Report to the Future Melbourne (Planning) Committee

Agenda item 6.2

Ministerial Planning Referral: ID-2020-6
111 Lorimer Street, Fisherman's Bend

MINISTERIAL PLANNING REFERRAL DELEGATE REPORT

Figure 11 - The proposed development together with nearby higher building forms (source: application plans prepared by Rothe Lowman)

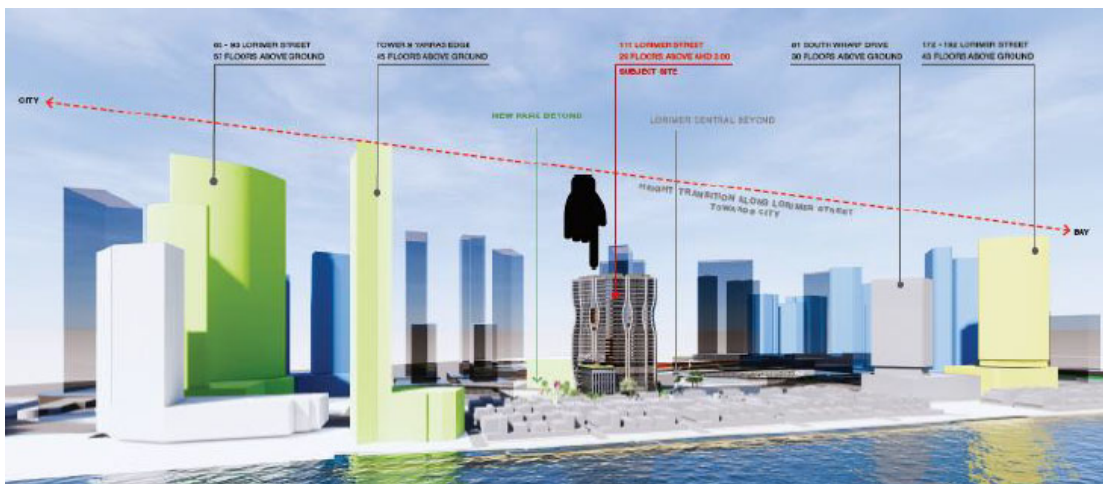
The applicant's justification for this increased height is in part existing, permitted and approved building heights in the surrounding area. As shown in Figure 11 below, these heights generally increase from west to east (from Fisherman's Bend to the central city).

Notwithstanding this, Schedule 67 is not structured in this way and in fact allows for both higher and lower forms to the west of the site (24 and 10 storeys respectively). Importantly, no height limit exists to the south-west and south-east and as such the applicant's contention that building heights increase from west to east may ultimately reflect the predominant future built form structure of this renewal area.

Figure 12 - Diagram confirming the development will not overshadow proposed public open spaces at the times specified by Schedule 67 of the DDO (source: application plans prepared by Rothe Lowman)

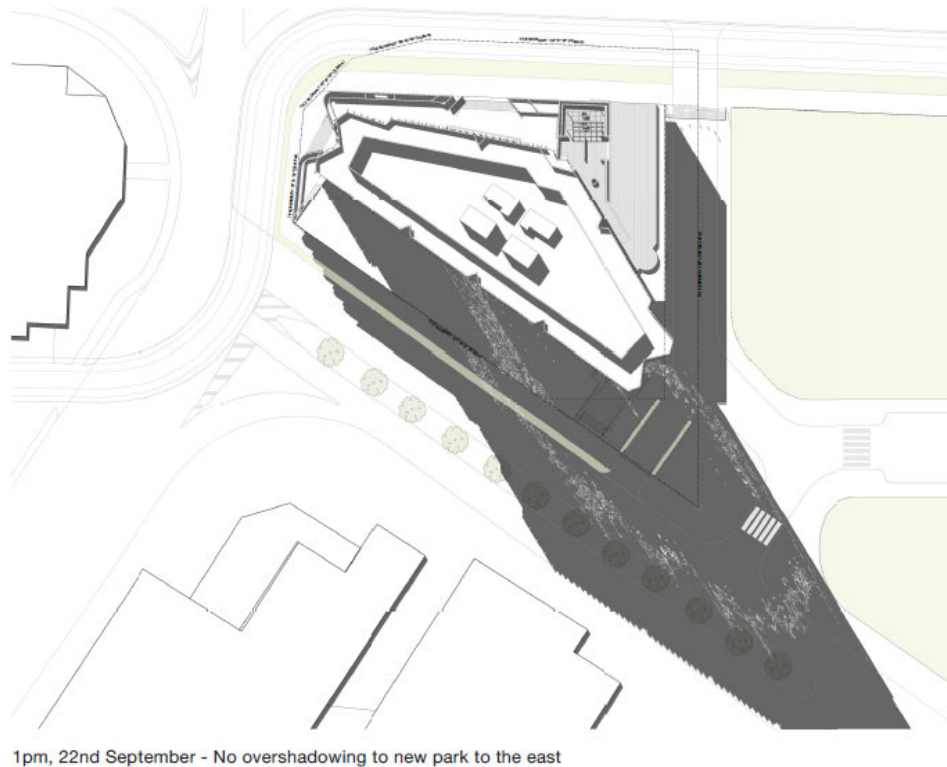
Schedule 67 states that the shadows cast over this open space between 10.00am and 1.00pm on 22 September should not extend beyond those which would be cast by a compliant street wall (six storeys). As shown in Figure 12 below, the proposed building would not overshadow proposed adjacent future open spaces between 10.00am and 1.00pm on 22 September. As such, it is considered that the height of the proposed building is acceptable in this regard.

Importantly, Council's Urban Designers did not explicitly object to the height of the building, advising only that it should not overshadow adjacent future open spaces. Again, as shown in Figure 12, this would not be the case.

Figure 15 - Map 3 of CCZ4 showing location of site within amenity buffer area. Site marked by yellow arrow (source: Melbourne Planning Scheme)

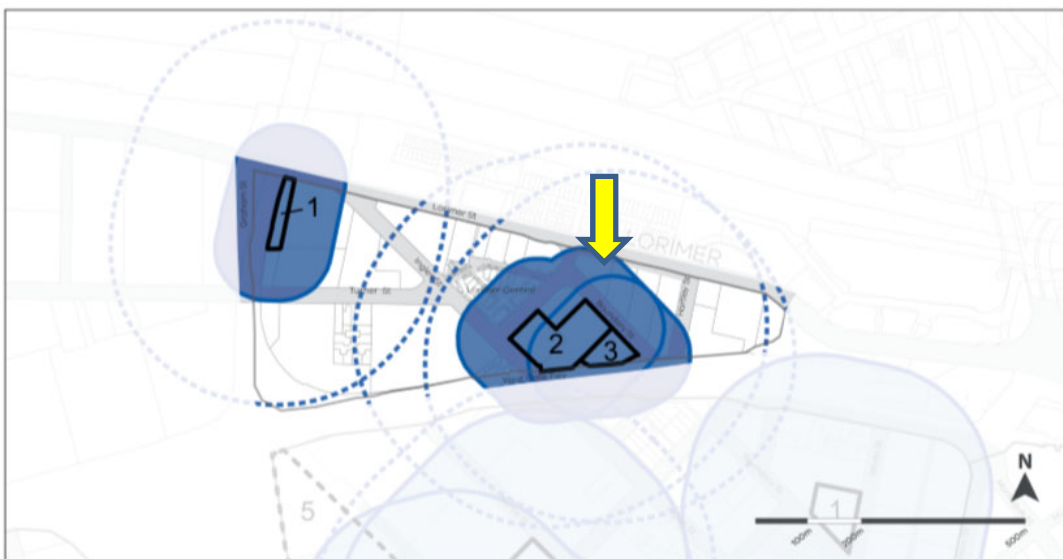
In accordance with Map 3 of CCZ4, the site is located within an identified amenity buffer area (refer Figure 15 overleaf). This is on the basis it is located within 100 metres of two concrete batching plants; Citywide (213 Boundary Road) and Hanson (223 Boundary Road and 310 Ingles Street). As such, in accordance with Clause 4.4 of CCZ4, an Amenity Impact Plan (Plan) is required.

Notwithstanding this, the Plan notes that external spaces on site will remain subject to the effects of nearby noise sources. As this relates to the aforementioned concrete batching plants, this could only be addressed by way of altered on site operations and this would require ongoing consultation and negotiation.

Figure 16 - Podium level winter garden detail
(source: application plans prepared by Rothe Lowman)

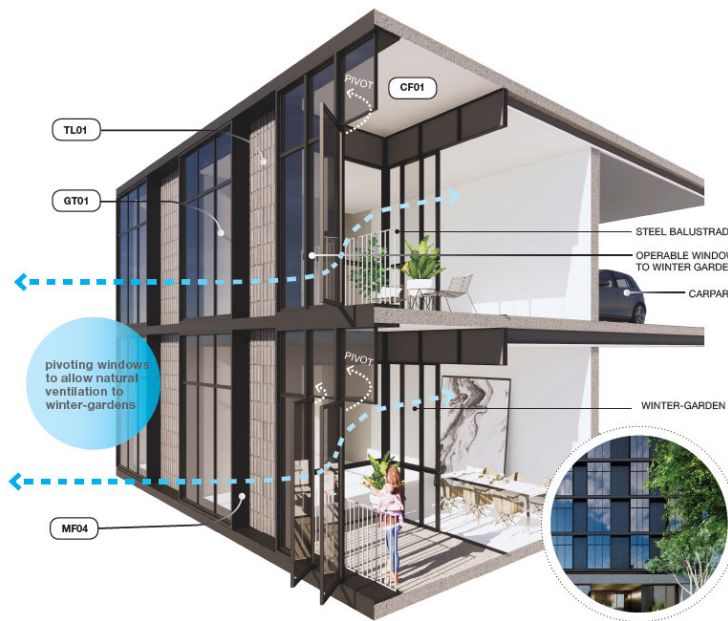
To safeguard the amenity and service needs of future occupants, it is recommended that additional winter gardens similar to those currently proposed be provided elsewhere. This would provide residents with a functional space serving as either an internal or external living area as and when the occupant chooses. To this end, operable louvres could be closed at noisier times to limit the effects of surrounding sources (nearby concrete batching plants and traffic) and at quieter times louvres could be opened to provide for a semi-external space and the natural ventilation of units.

Figure 16 below shows the podium level winter gardens currently proposed. A response similar to this is recommended in accordance with the preceding discussion.

Without prescribing a particular minimum percentage, it is considered that the majority of units should feature open spaces/winter gardens, be it in accordance with the preceding suggestions or otherwise. This would again comply with the provisions of Clause 58.05-3 and ensure future occupants benefitted not only from the suite of communal spaces on site but also dedicated and flexible private open spaces.

- c). The provision of additional flexible internal/external spaces similar to the winter gardens provided at podium level. These spaces should be provided at both podium and tower levels and comply with the minimum requirements of Standard D19 of Clause 58.05-3 of the Melbourne Planning Scheme;

**Figure 17 - Tower level apartment detail showing proposed balconies
(source: application plans prepared by Rothe Lowman)**

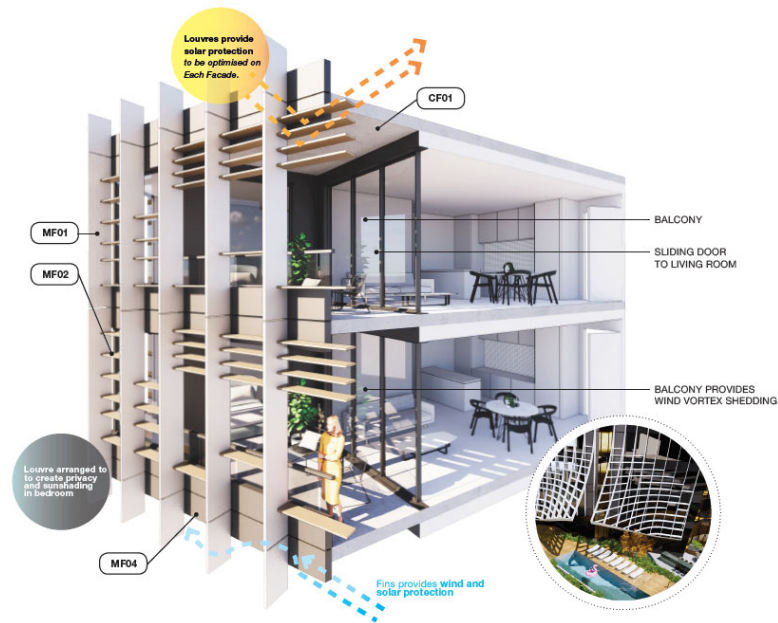
Whilst the balconies of Type D and H units are not the necessary minimum dimension at certain points, this can be accepted on the basis the overall sizes of these balconies (eight square metres) still complies with Standard D19. To this end, these balconies will still provide for the service needs of future occupants.

On the basis the provision of additional open spaces/balconies would also likely require alterations to the feature metal screen and, in turn, effect the wind mitigation strategy of the development, this represents a fundamental change.
